ISSUED FOR ADDENDUM 1 CEA 2015.10.15
 AREA OF NEW CPT, LOCATIONS OF RUBBER COVE BASE, LOCATIONS OF NEW ROLLER BLINDS

PROJECT:
 FPS TRAINING
 CARPET & BLIND RENO
 2546 McPhillips Street
 SHEET TITLE

NEW CONSTRUCTION

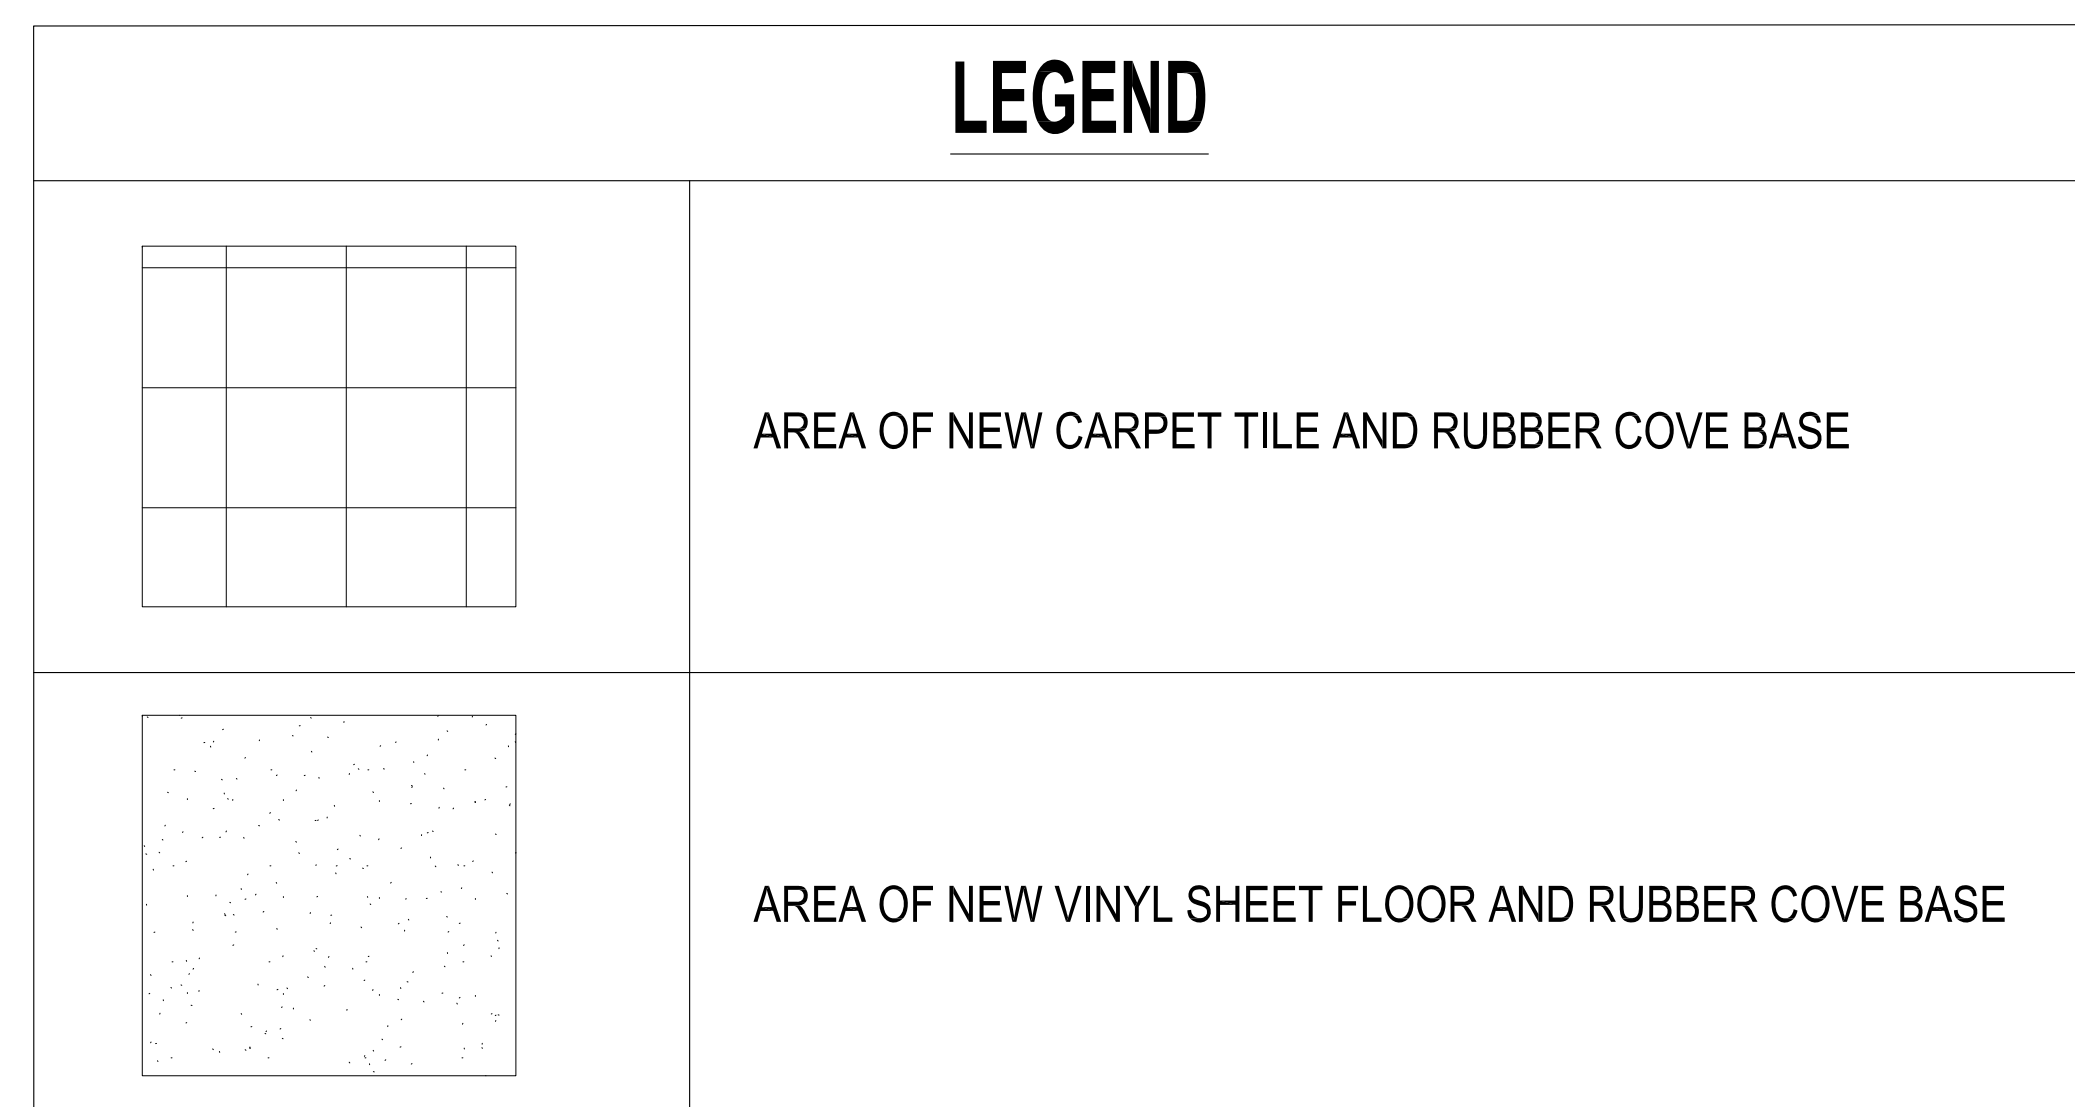
- REVISION NOTES:**
- EXISTING VINYL COMPOSITE TILE TO REMAIN.
 - NO RUBBER COVE BASE UNDER BASEBOARD HEATERS (TYP.)
 - CHANGE TO LOCATIONS OF ROLLER BLINDS IN/AROUND VESTIBULE
